Docket Item # 7  
BAR CASE #2008-0079

BAR Meeting  
June 4, 2008

**ISSUE:** Signage  
**APPLICANT:** Young Yoon/TLC Hair Salon  
**LOCATION:** 106 North Patrick Street  
**ZONE:** CD/Commercial

**Figure 1: Proposed elevation**

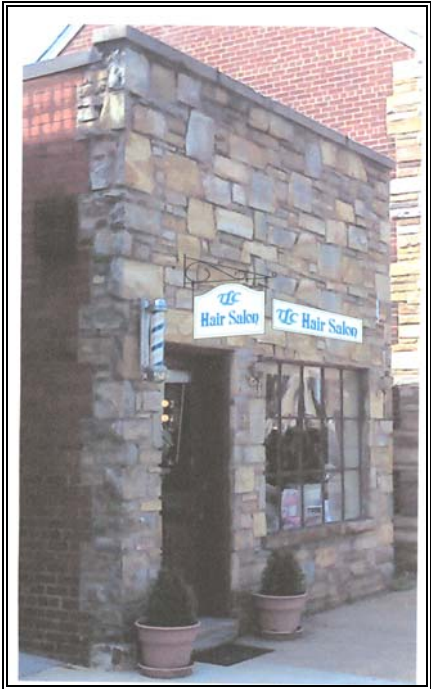
The hanging sign will measure 18” by 24” with a rounded top mounted on a 30” black metal scroll bracket. According to the drawings, it appears that the sign bracket will be anchored into the stone veneer and not the mortar joints. The sign will be constructed of wood (MDO) with a white background with the words “HAIR SALON” in dark blue and the business logo, “TLC”, above in dark blue with a light blue accent.

Staff believes that the proposed wall sign and hanging sign are each appropriate. However, two signs in such close proximity on this small commercial building seem redundant, especially since there is an existing barber pole also identifying the building. The *Design Guidelines* state that, “generally, only one sign per business is appropriate.” Staff recommends approval of the wall sign, rather than the hanging sign, because it provides the most visibility from both King Street and North Patrick Street. Staff recommends that any signs approved be anchored into the mortar joints and not the stone veneer.

C-1 Wall letters / signs must comply with USBC [H103-H111] Please indicate the method to be used for anchoring the letters to the wall.

C-2 Projecting, hanging signs must comply with USBC [H103-H107, H112] for type of materials, maximum projection, vertical clearance below all parts of the sign, and additional loads.

**IV. STAFF RECOMMENDATION:** Staff recommends approval of the wall sign and not the hanging sign, and that any signs approved be mounted into the mortar joints and not the stone veneer.
